BOARD OF DIRECTORS SAN LORENZO VALLEY WATER DISTRICT REGULAR MEETING AGENDA MAY 2, 2024

SUBJECT: Contract Change Orders - Glen Arbor Bridge Pipeline Project

The Board of Directors directs the Interim General Manager to execute Contract Change Orders 1 through 12 for payment to Monterey Peninsula Engineering (MPE) as part of the District's Glen Arbor Bridge Pipeline project.

RFI No. **007**

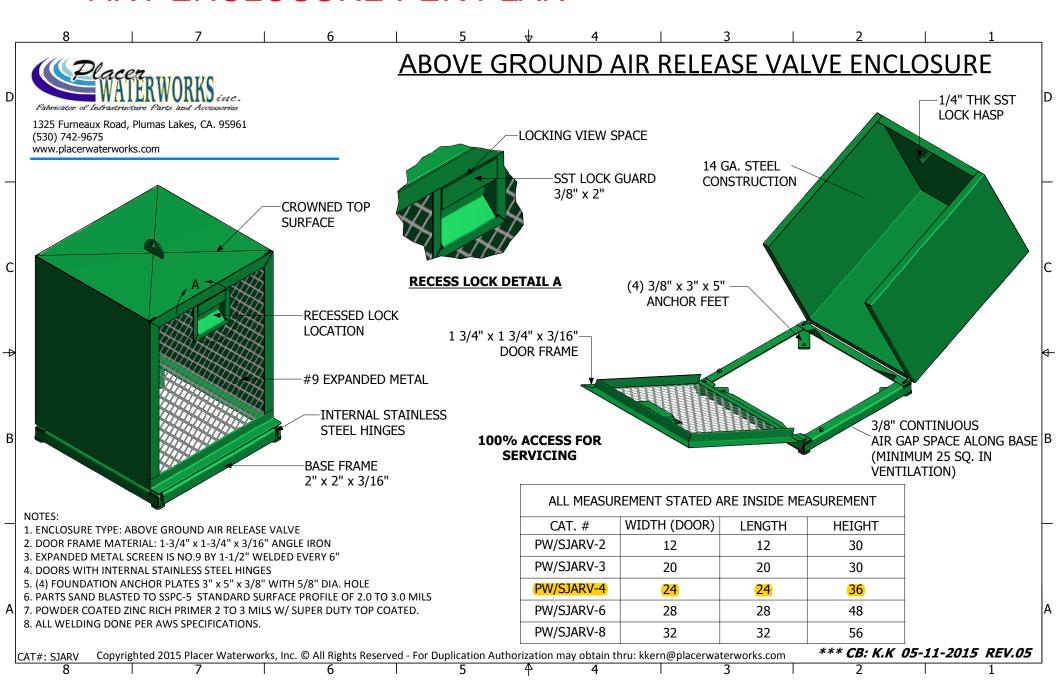
The ARV enclosure specified on the plans will not work properly for the bridge application. If installed per plan, the bottom panel and side door would swing open (while the box is anchored) and wouldn't be able to shut without a bridge inspection unit. Please see the suggested ARV enclosure type attached. Please advise if the suggested type will be suitable. If it is considered suitable, please specify what modifications would be required (closed bottom, mounting brackets, etc.).

The enclosed suggested ARV Enclosure VC-316 is acceptable. We have modified the attached details as shown on the attached final sheet.

RFI No. **018**

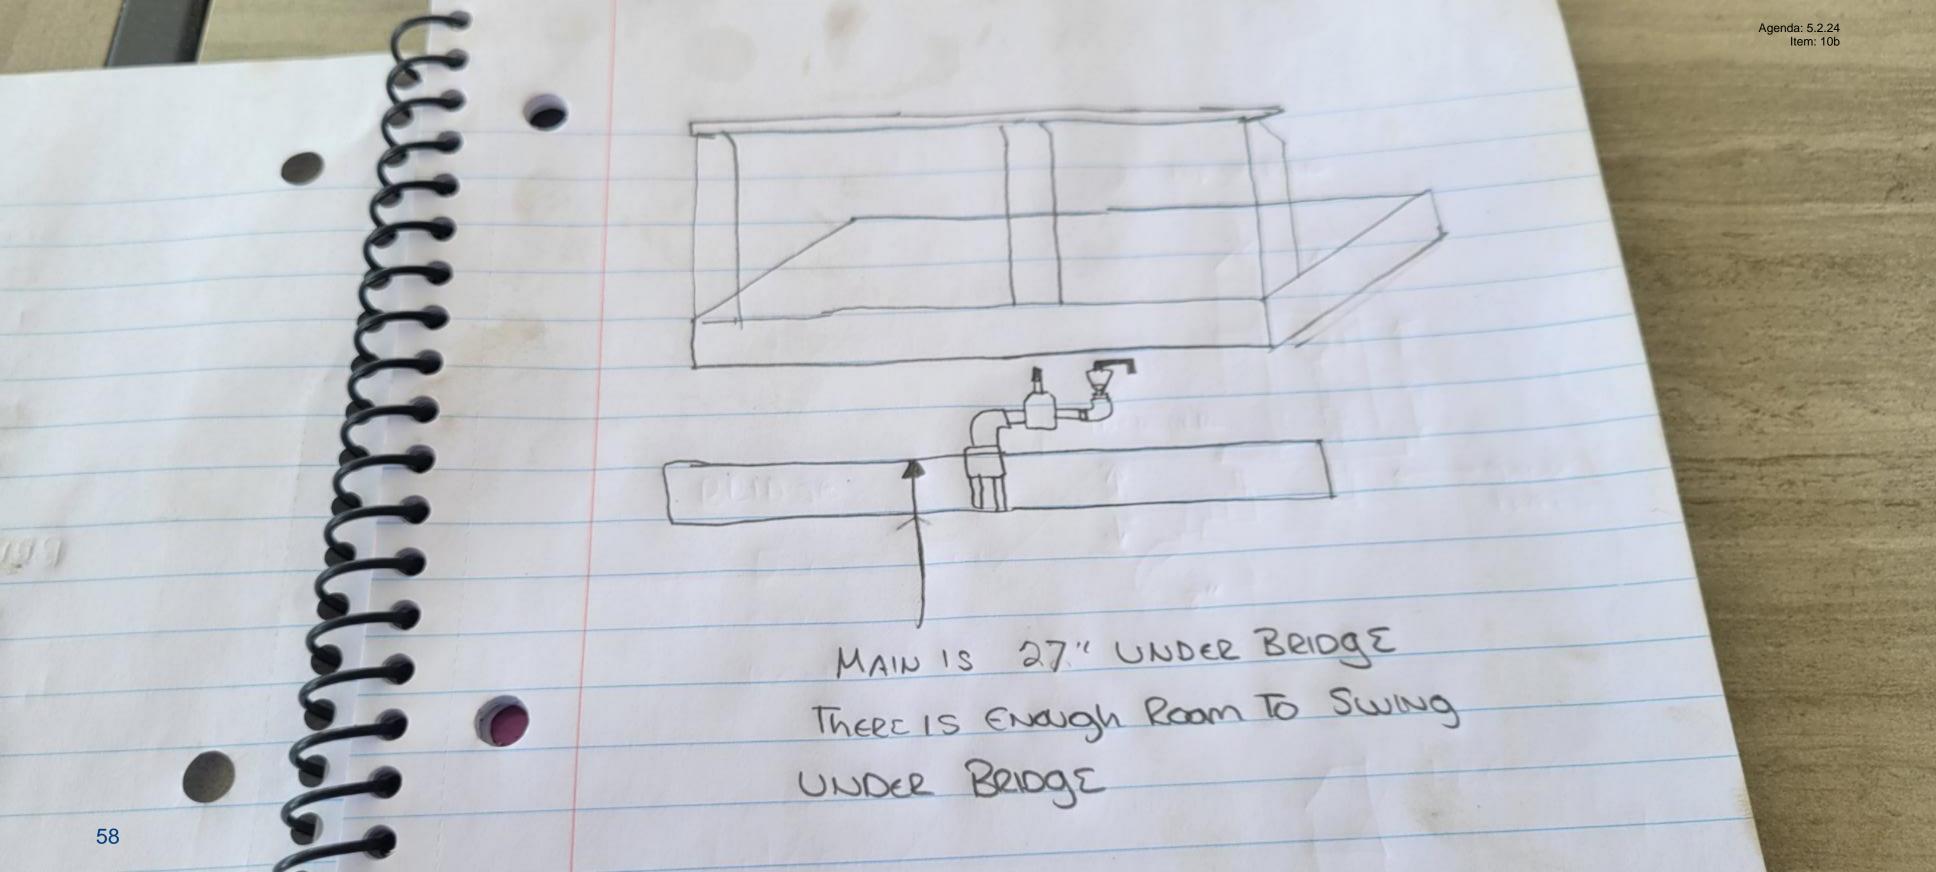
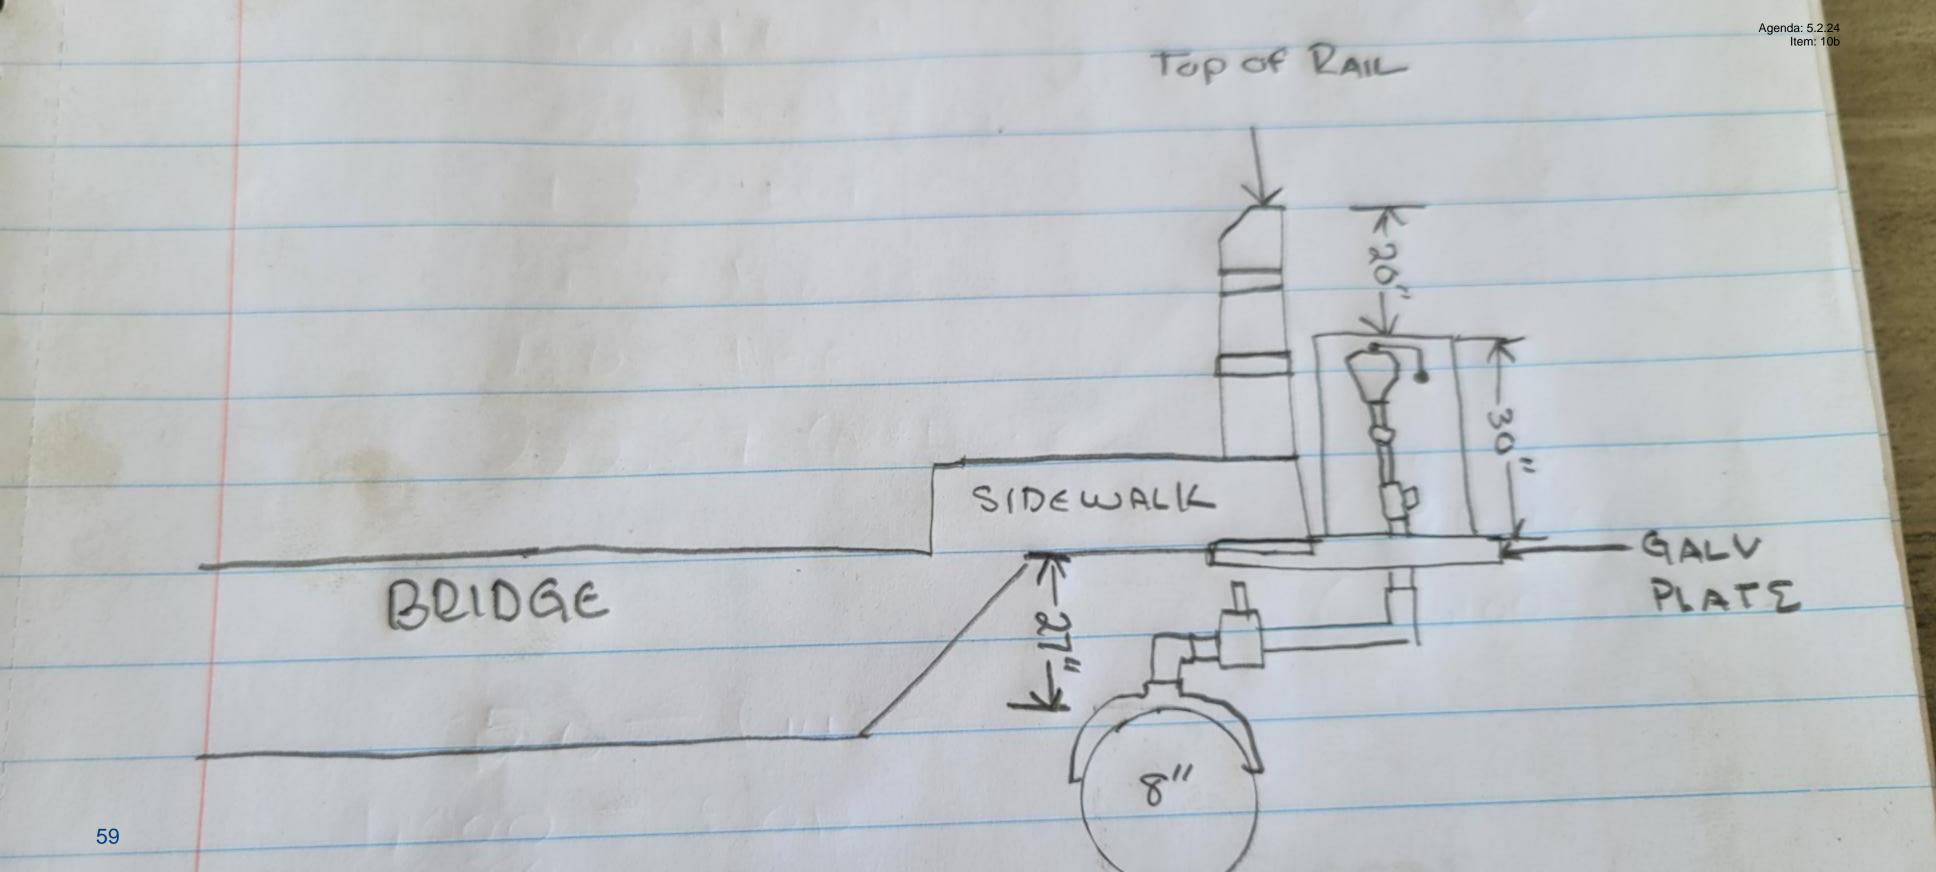
The ARV enclosure is 2-3 weeks from delivery. MPE is looking for direction from the District whether to keep the ARV enclosure as directed in a previous RFI, or to modify the existing ARV layout in a way that prevents tampering without an enclosure.

Based on the ARV layout given in the previous RFI response, The ARV cannot be operated without the use of a bridgewalker unit. In order to prevent costly rental fees while waiting for the ARV enclosure to deliver.
